PE03-044
FORD
5/13/2005
APPENDIX I
BOOK 16 OF 28
PART 2 OF 4

**Advanced Product Quality Planning
Status Report**

Teleflex Automotive – U137/P131 Adjustable Pedals

Adjustable Pedal
 Brite
 Mini-Trip at R/T 10/17/2000

FR131 BRAKE PEDAL SWING STUDY

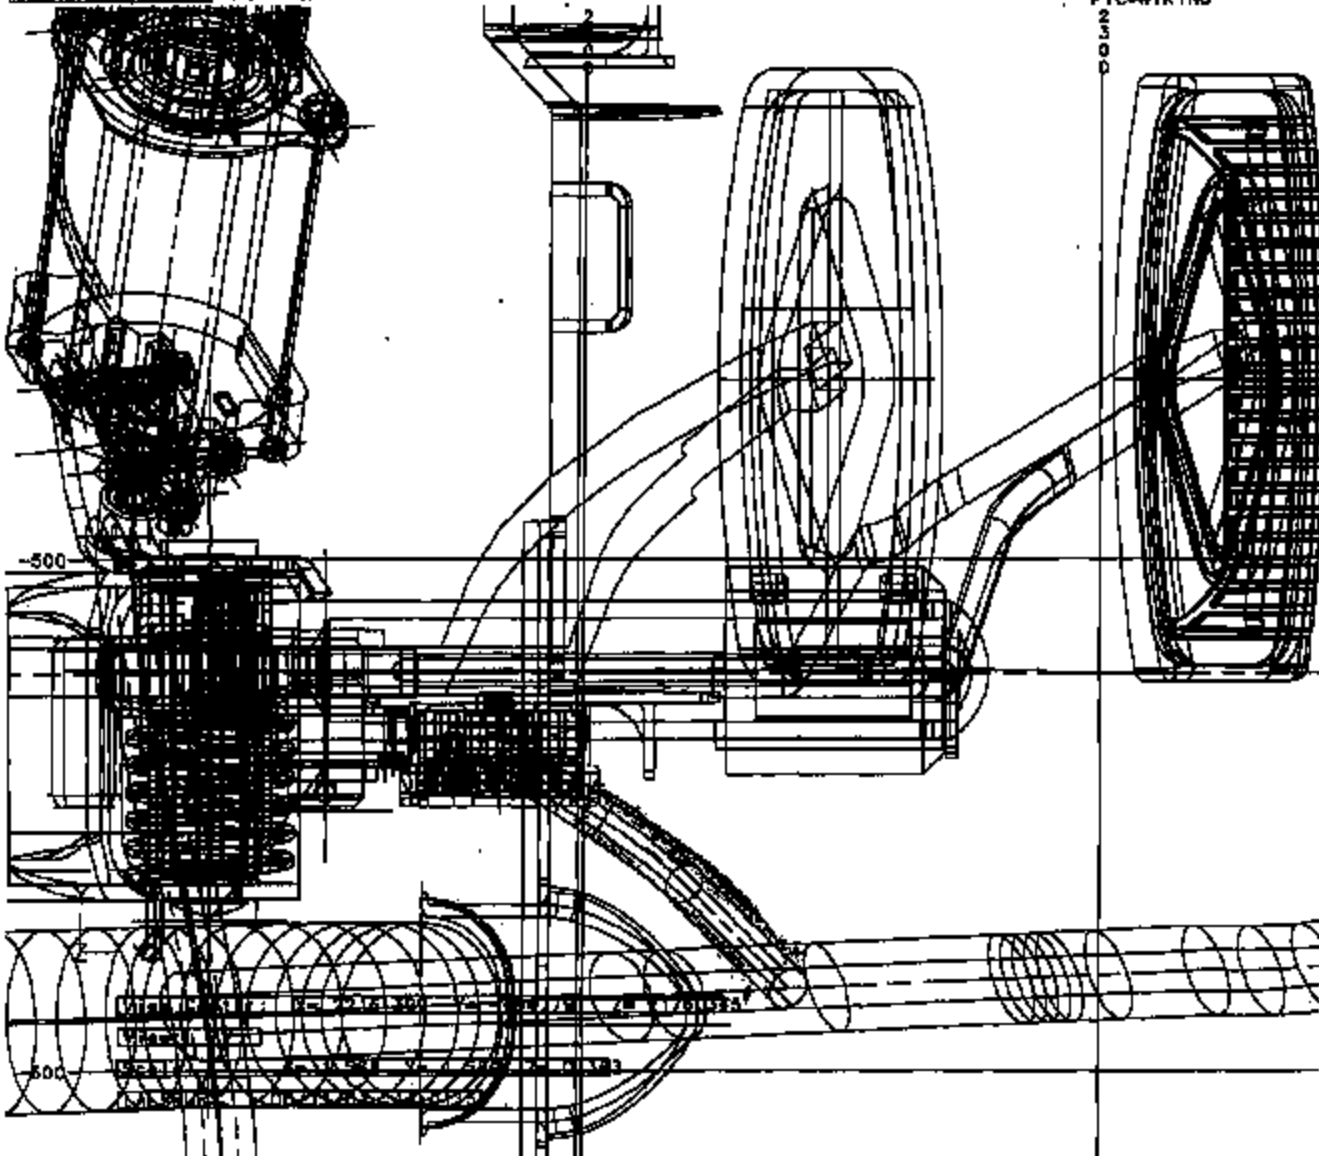
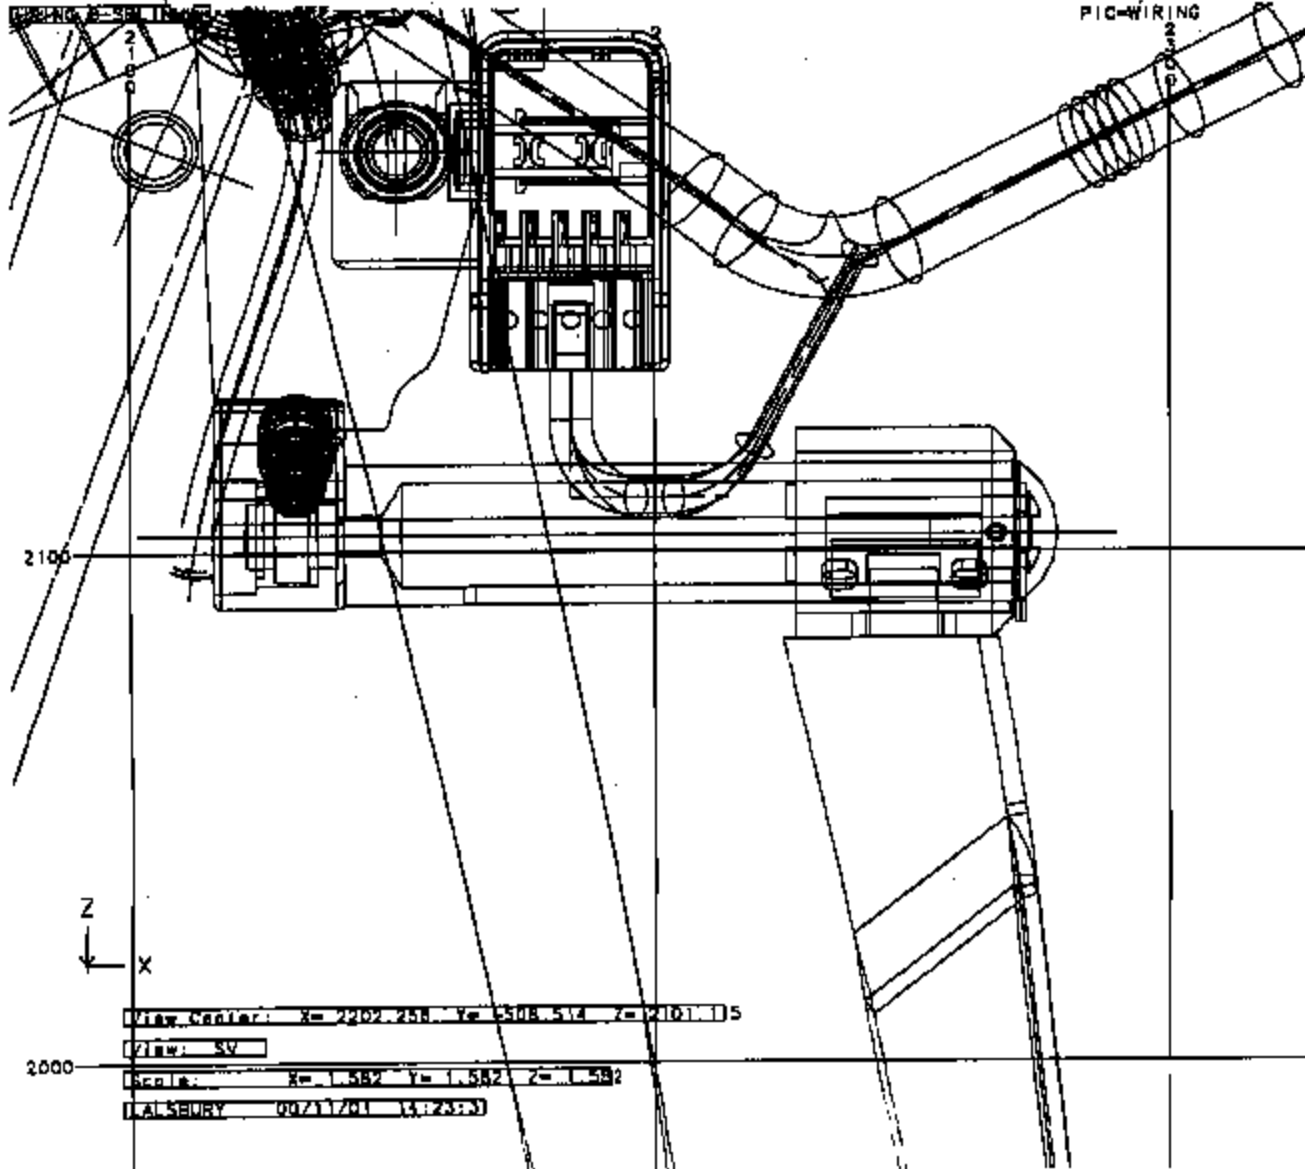
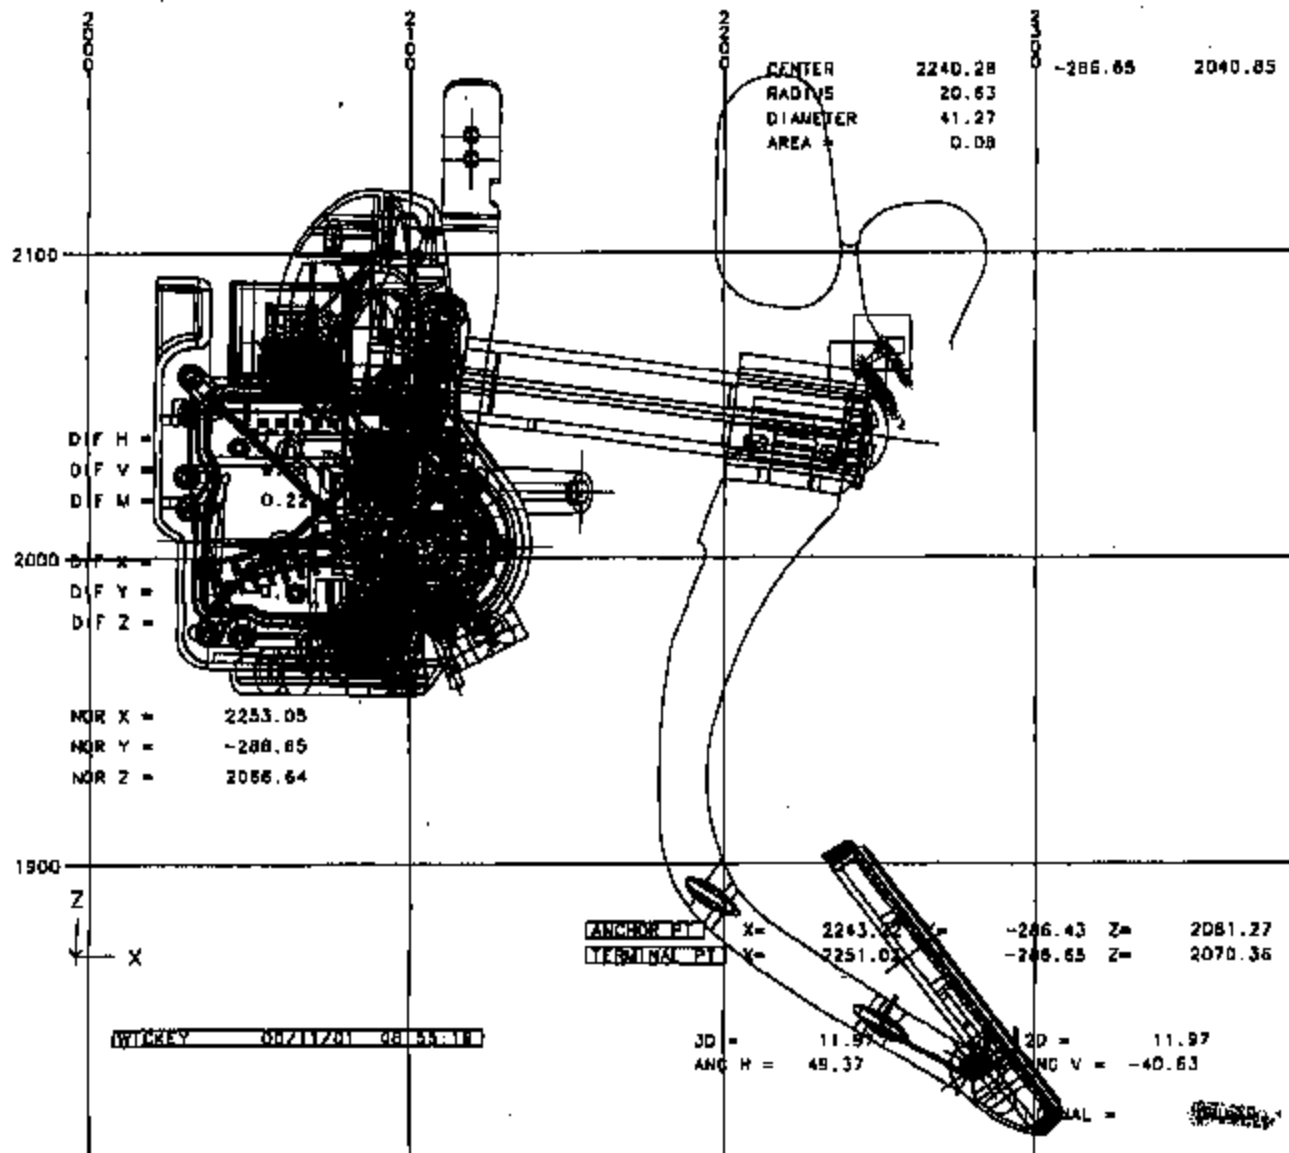
Brake Light Switch (BLS)	Switch wiring can contact brake pedal track rod. Wiring will not get chafed on track rod when adjusting pedal position or applying the brake.		C11167348	T&O	T&O	Under investigation - CAD shows wiring interference. Downstream team should maintain clearance 12 mm. Brain relief cap under investigation to provide wiring clearance.	AFL/Polab/Talbot	P131U137	R
Rest Seat (Dashed & Gas)	Clearance between rest seat and Accel. Track rod is tight when the pedal side is full depressed.	Difficult to install rest seat on metal grill with adjustable pedal installed. Duct was broken on mating assembly.	C11167349			New duct designed to fit with adjustable pedal. CAD shows that there is 17 mm between pedal-assembly and rest seat. Prototype duct provided for trial run.	Leary/Talbot	P131U137	Y
Brake - gas	Brake worn in lower 40% of pedal on brake assembly in vehicle. Some pedals are very solid and other pedals are loose. - (Rattle problem)		C11159412			Prototype duct provided for trial run.	Talbot	P131U137	Y
